ADDENDUM NO. 2

**Snell Building (SNLB) Deans
Office Remodel**

WPA ARCHITECTURE

April 2, 2024

A2.1

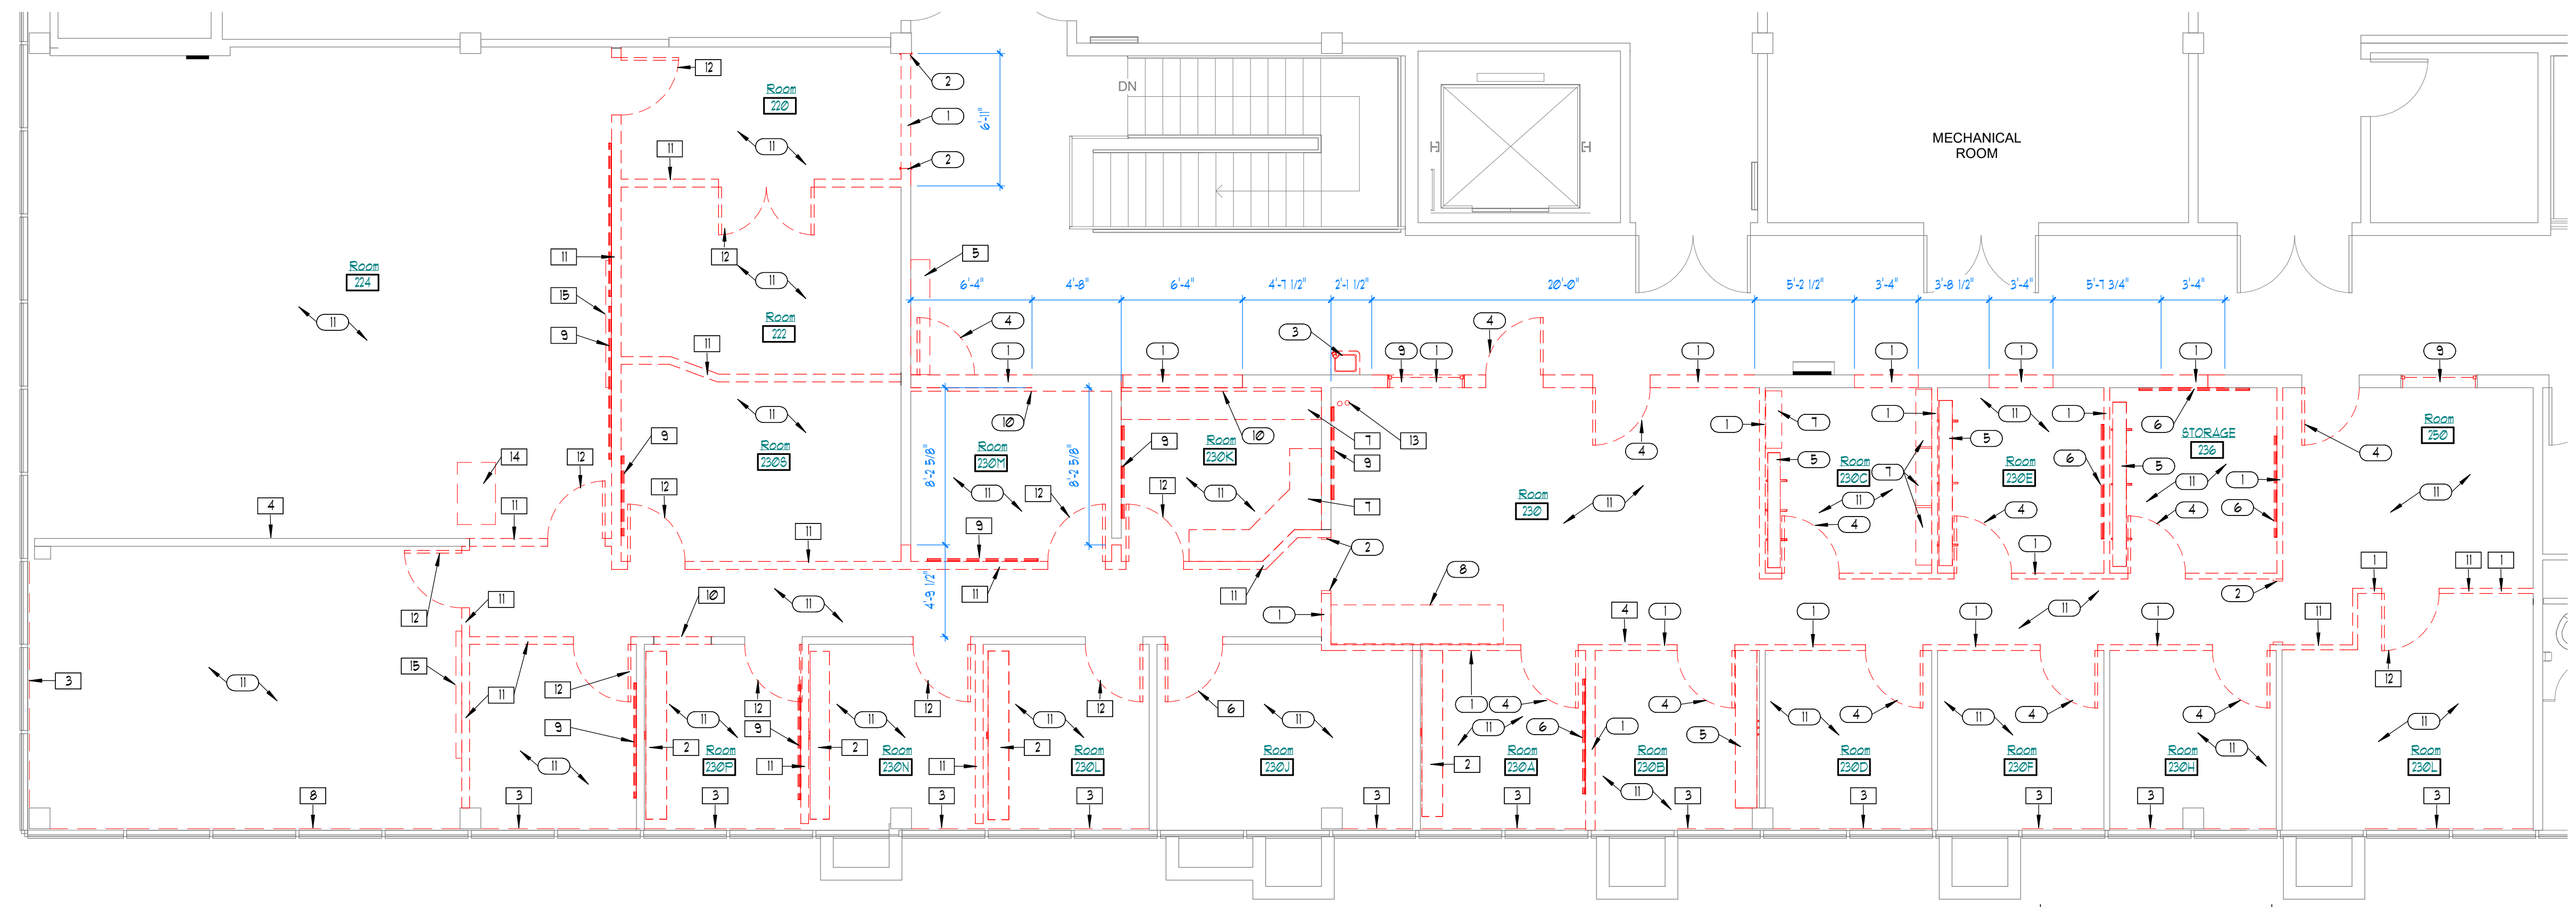
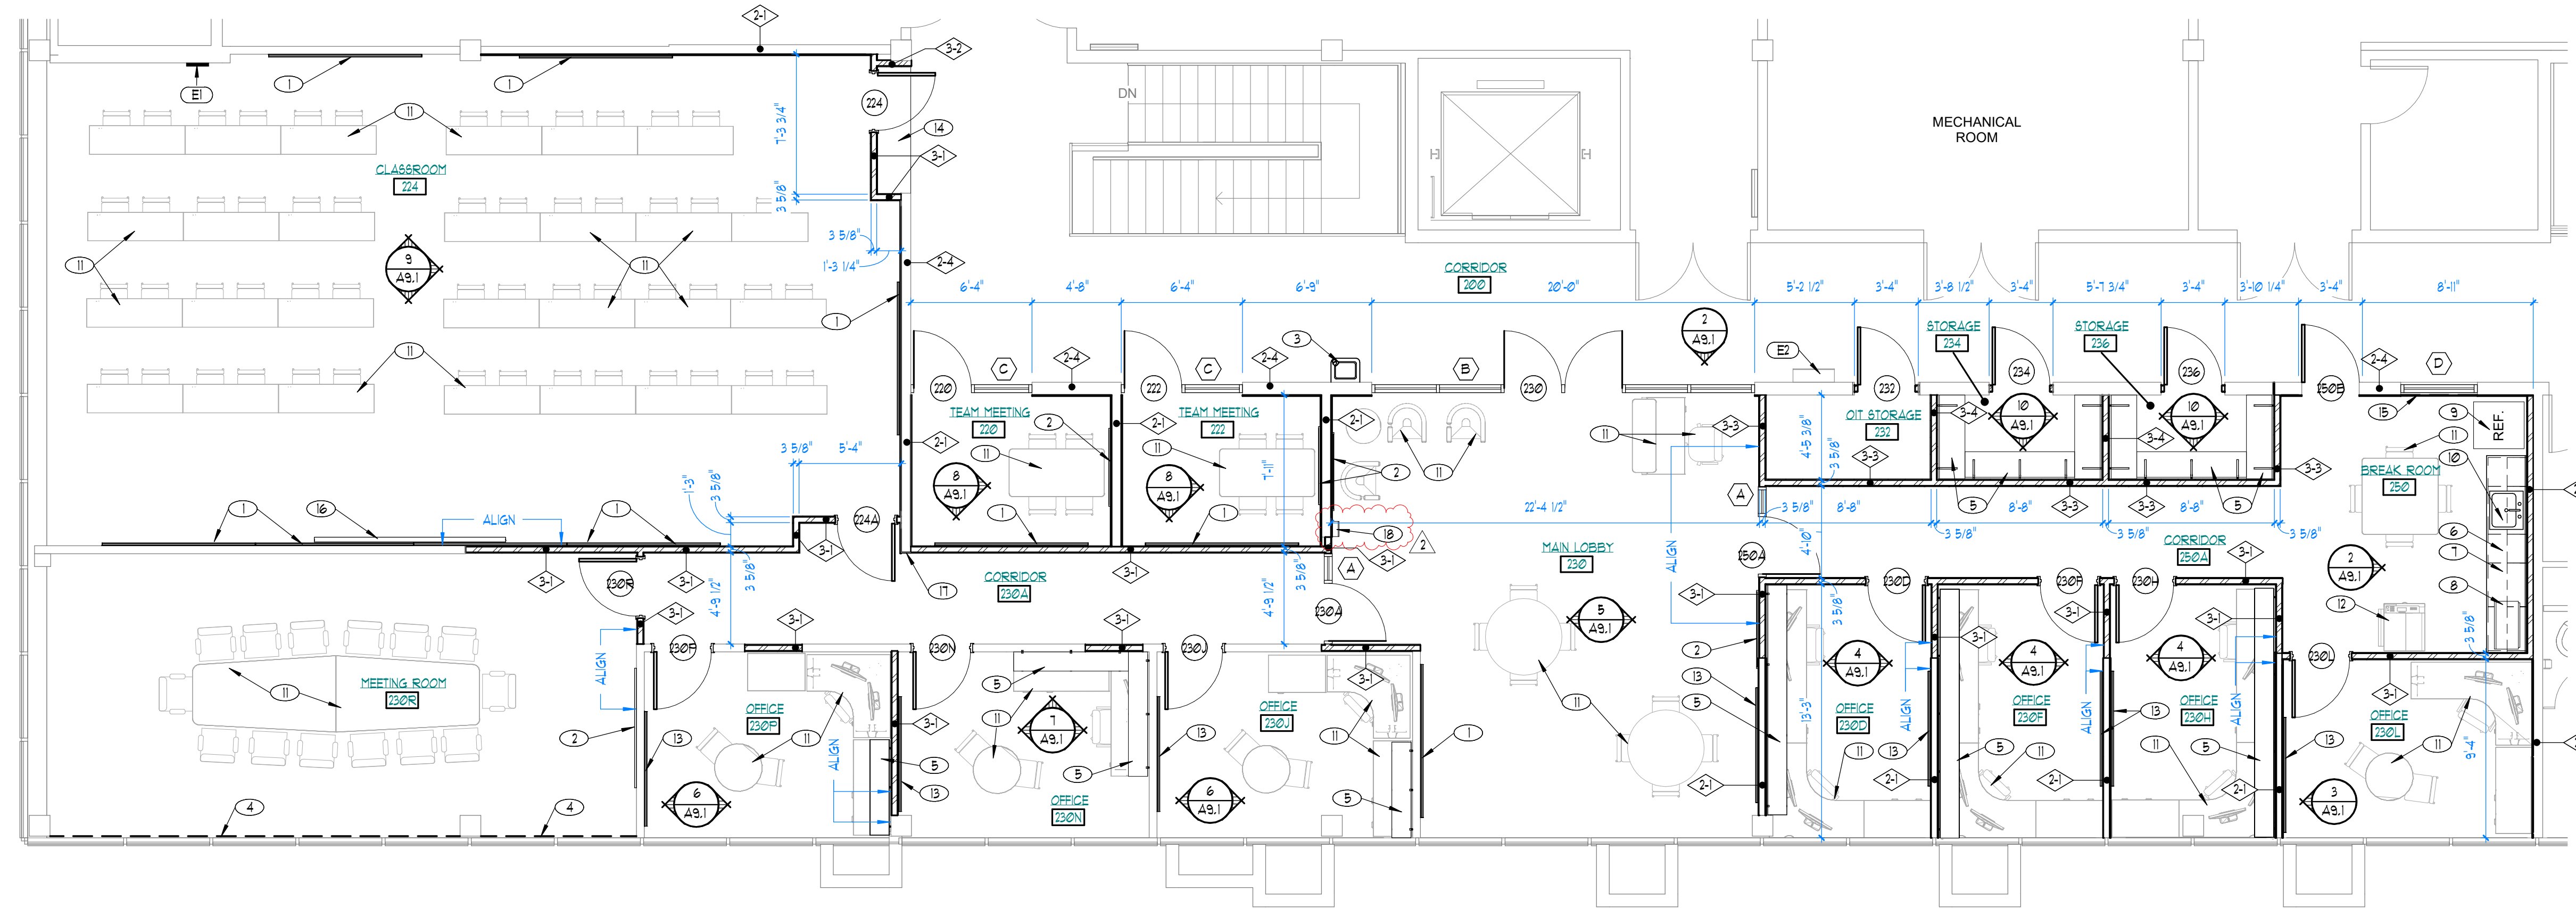
Sheet A2.1 – Added Surface Mounted Fire Extinguisher Cabinet.

1. Per A3.1, shelving is noted to be a white melamine w/ plastic edges, but A9.1 sheet notes 11 & 16 direct to match door color and wood species. Please advise. **Shelving will be white melamine w/ plastic edges. See Addendum 02.**
2. Per Remodel Plan 2/A2.1, (10) 8' x 4' and (8) 6' x 4' whiteboards are

noted. Demo Plan 1/A2.1 notes salvaging (7) whiteboards. Do the (7) salvaged whiteboards offset the (18) noted in the remodel plan? If so, please advise on existing whiteboard sizes to modify counts needed for 8'x4' vs. 6'x4'. **In total, there will be (11) whiteboards salvaged (9 – 6x4, and 2 – 8x4) that will need to be reinstalled. Any excess whiteboards will be salvaged to the owner.**

15. Sheet A2.1, Sheet Note 1 & 13 calls for whiteboard with no spec, please advise. Section 101100 – Visual Display Units added to Project Manual – See Addendum 02

16. Sheet A2.1, Sheet note 16 calls for motorized projector screen with no spec, Please advise. The projector screen will be furnished by the Owner and installed by the contractor.

18. A2.1 note 10 calls for the wall to be removed please advise if the wall is CMU. If so, please confirm the wall thickness and if it has asbestos and if its solid grouted. This is a 3 5/8" metal stud wall with gypsum board on both sides.

19. Note 10 on the demo plan calls for a saw cutting a new opening. Please advise if the contractor will be required to add structural reinforcement at this location. Please advise. Note 10 on the demo plan is referring to a metal stud wall. Any saw cutting of CMU walls will be done by the asbestos removal contractor.

3-1 WALL CONSTRUCTION TYPE
1 1/2" x 1'-0"

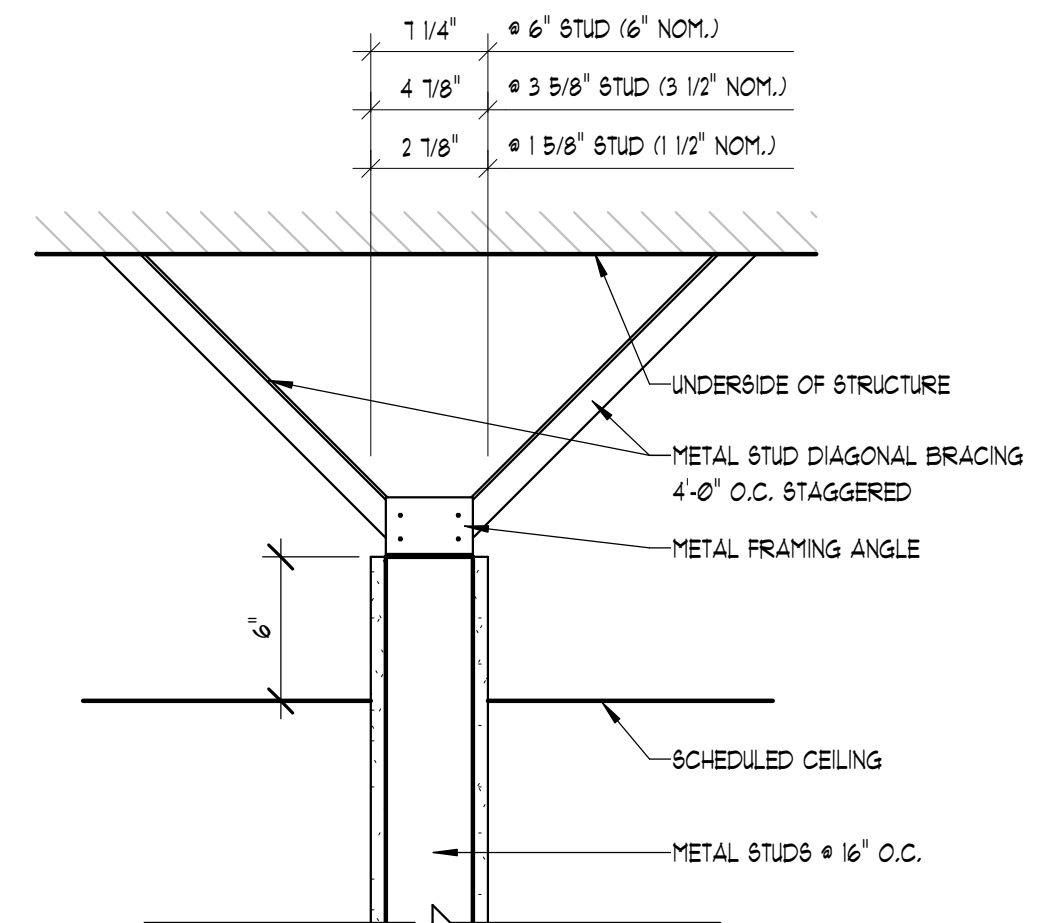
9. Please confirm which wall type is required above the new door openings in the existing CMU Walls. **Wall Construction Type 3-1, see window and door details on sheet A3.2.**

1 WINDOW TYPES
1/4" = 1'-0"

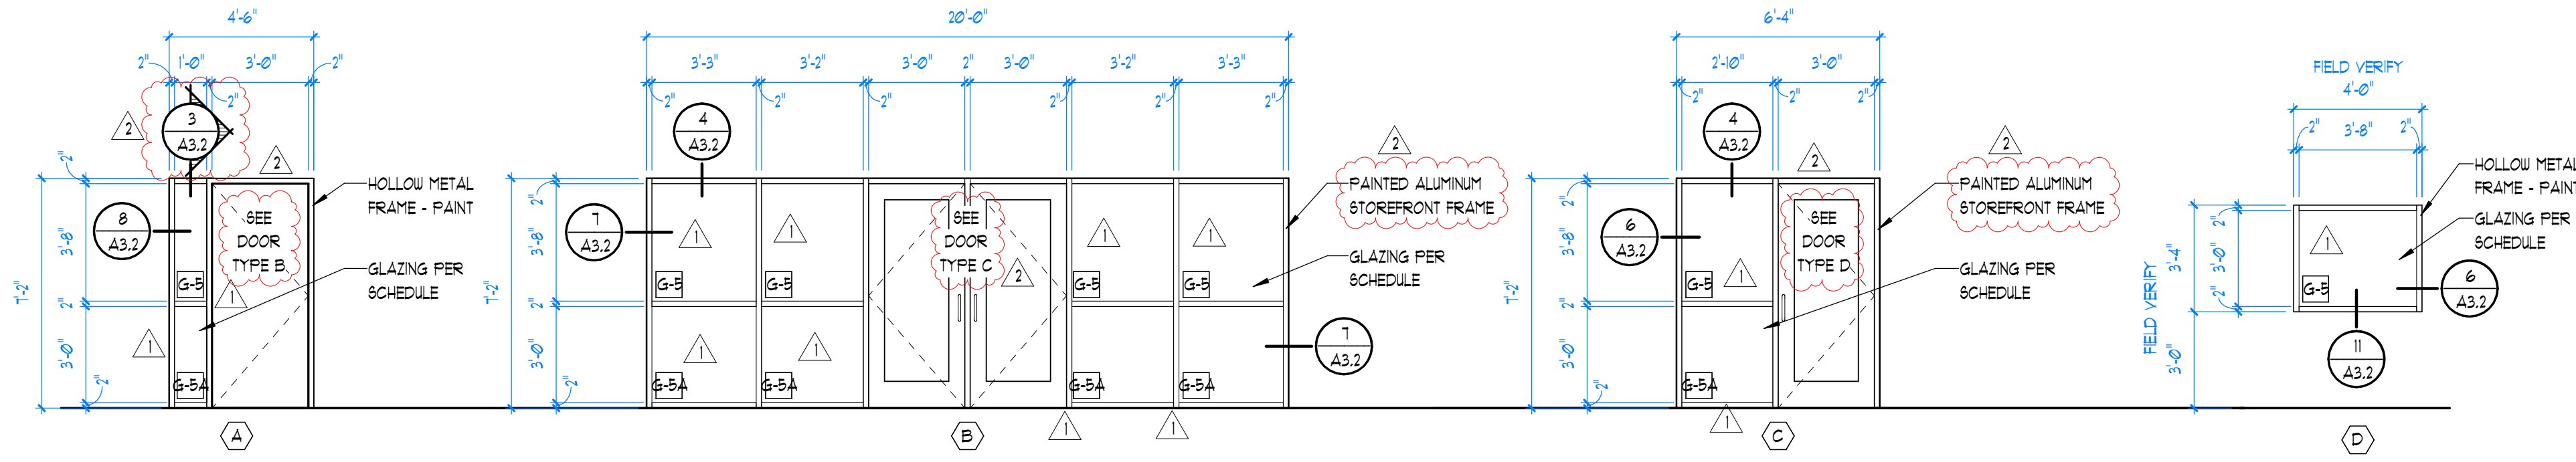
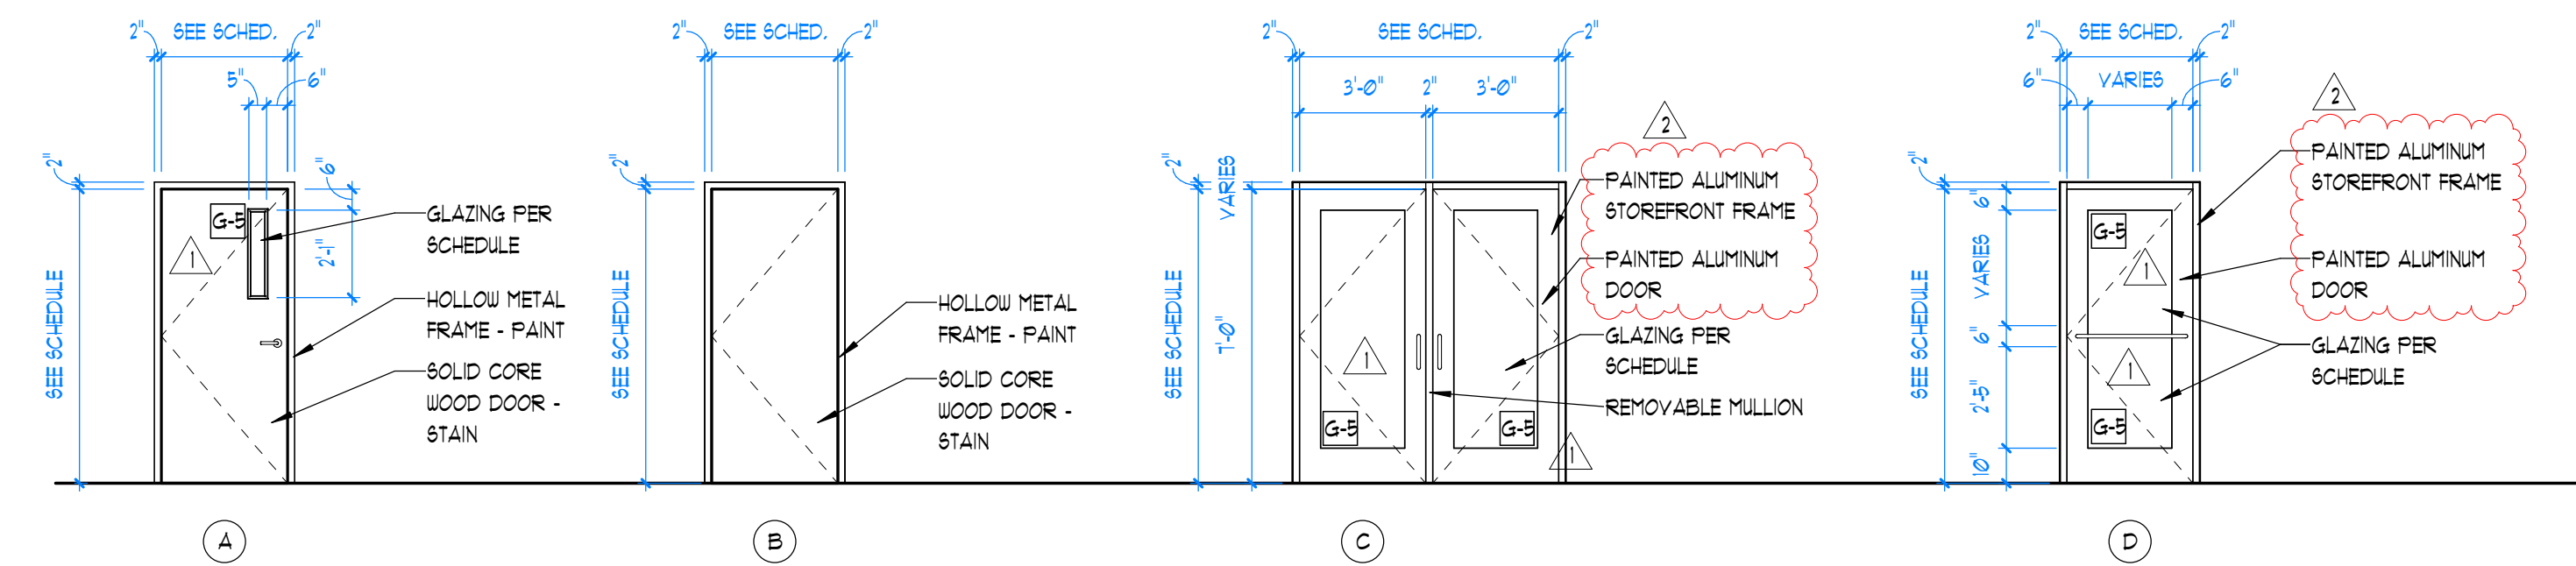
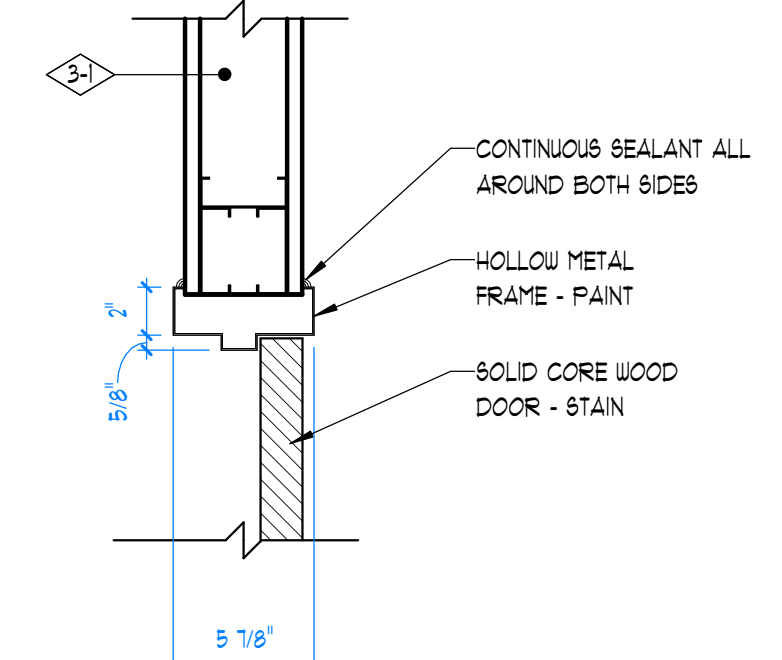
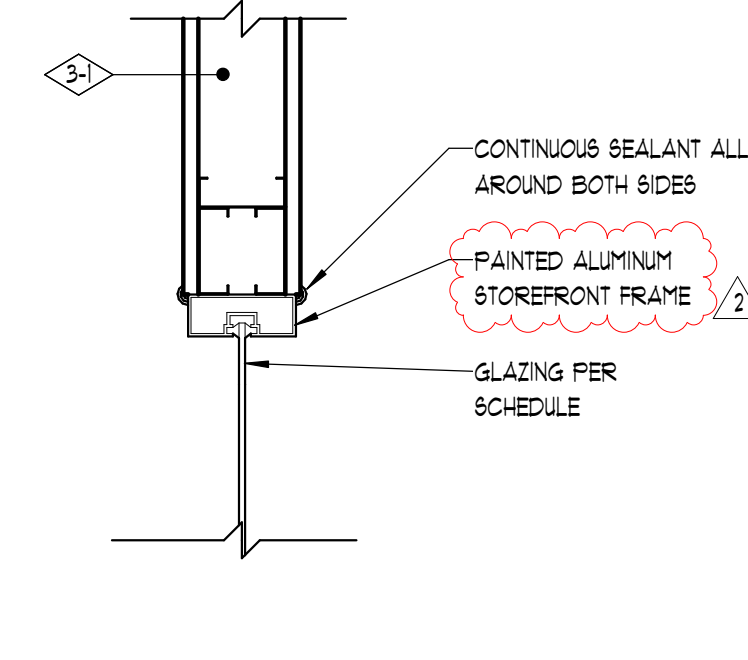
Sheet A3.2 – Changed Head Detail Callout on Window Type A to 3/A3.2, changed door callouts to show correct doors on Window Types A, B, and C. Changed Powder Coated Aluminum Storefront Frame to Painted Aluminum Storefront frame.

4. FYI: There appear to be a few typos at window types. "SEE DOOR TYPE _" notes don't appear to reference the correct doors. Additionally, some HM framed windows refer to an aluminum head detail (4/A3.2) **See Addendum 02 for corrections.**

17. There seems to be an error on the door schedule for doors # 230A and 250A, they are scheduled as door types C (pairs, aluminum) but appear to be in the window type A (single doors, Hollow metal). Please advise. See Addendum 02 for corrections.
